Prairie Island Nuclear Generating Plant
1717 Wakonade Drive East
Welch, MN 55089

Prairie Island Nuclear Generating Plant Units 1 and 2
Docket Numbers 50-282 and 50-306
Renewed Facility Operating License Nos. DPR-42 and DPR-60

Responses to Requests for Additional Information Regarding Prairie Island Nuclear Generating Plant's Overall Integrated Plan Submitted in Response to March 12, 2012 Commission Order Modifying Licenses with Regard to Requirements for Reliable Spent Fuel Pool Instrumentation (Order Number EA-12-051) (TAC Nos. MF0832 and MF0833)

**Responses to Requests for Additional Information Regarding
Reliable Spent Fuel Pool Instrumentation
(Order EA-12-051)**

Revised Figure 2 – Simplified Elevation Sketch of Levels (Not to Scale)

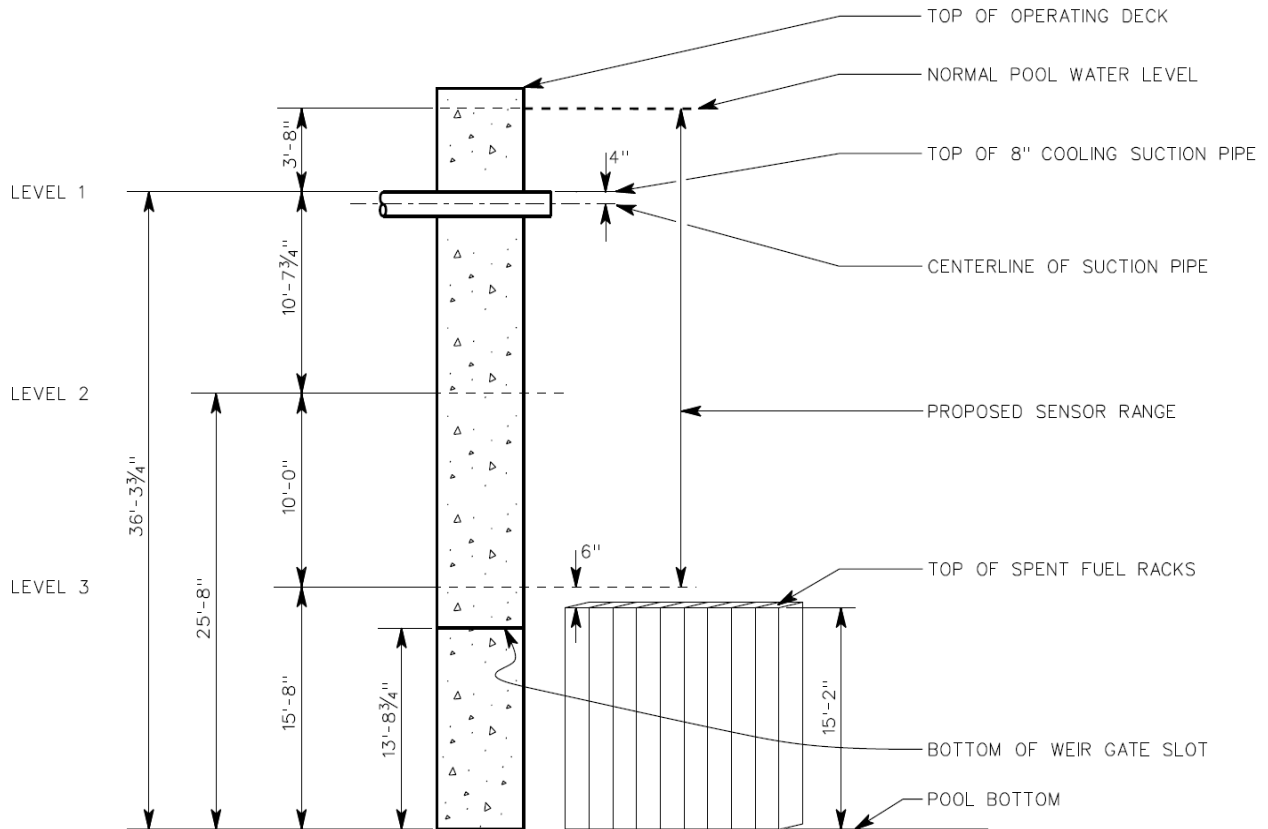
- a) For level 1, specify how the identified elevation represents the HIGHER of the two points described in the NEI 12-02 guidance for this level.*
- b) For Figure 2, indicate the portion of the level sensor measurement range that is sensitive to measurement of the fuel pool level, with respect to the Level 1, Level 2, and Level 3 datum points.*
- c) The OIP states, in section 3.3, Mounting, "An evaluation of other hardware stored in the SFP will be conducted as part of the detailed design to ensure it will not create adverse interaction with the fixed instrument locations." Please provide a discussion regarding dose rates for stored spent fuel versus that of other material that may be stored in the pool.*

- b) Figure 2 from the original OIP has been revised to indicate the proposed level sensor range as shown below. The proposed level sensor range will indicate from Level 3 up to the normal pool water level. NSPM's current plan is to begin design of the SFPI system by the end of September 2013, with design completion expected by the end of January 2015. Any changes to the requested information on level sensor range will be provided with the February 2015 six-month status report.

Revised Figure 1 – Spent Fuel Pool General Layout (Not to Scale)

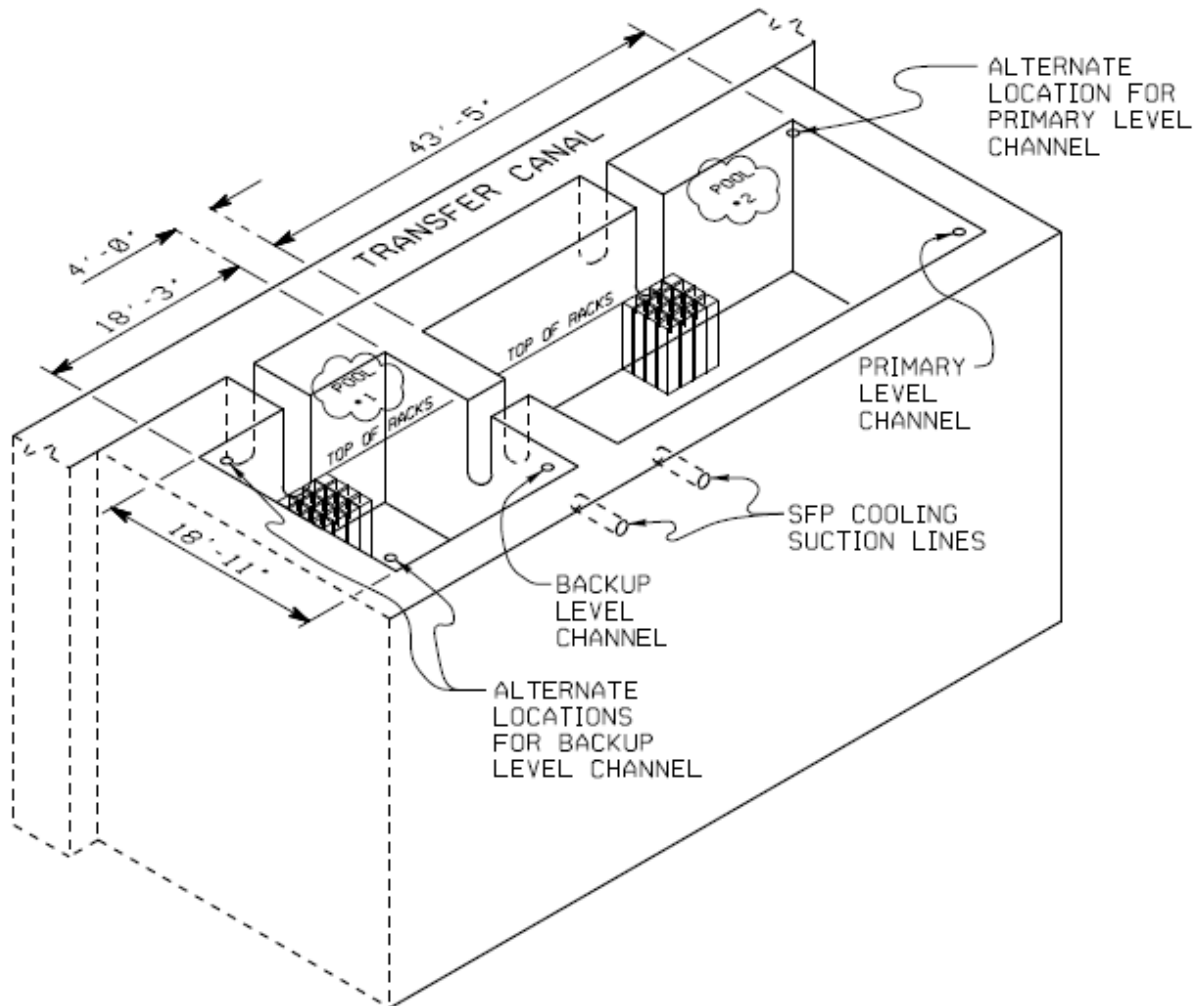
Please modify the sketch in Figure 1 or provide a marked-up plant drawing of the plan view of the spent fuel pool area, depicting the spent fuel pool inside dimensions, the planned locations/ placement of the primary and back-up spent fuel pool level sensors, and the proposed routing of the cables that will extend from the sensors toward the location of the local electronics cabinets and read-out/display devices in the main control room or alternate accessible location.

The sketch provided as Figure 1 in the original OIP has been revised to provide the spent fuel pool inside dimensions. Revised Figure 1 is provided below. The proposed locations/ placement of the primary and back-up spent fuel pool level sensors remain on the revised Figure 1 sketch provided below. The proposed routing of the cables has not been determined. The final component locations and cable routing will be available upon completion of the final design. NSPM's current plan is to begin design of the SFPI system by the end of September 2013, with design completion expected by the end of January 2015. The requested information will be provided with the February 2015 six-month status report.
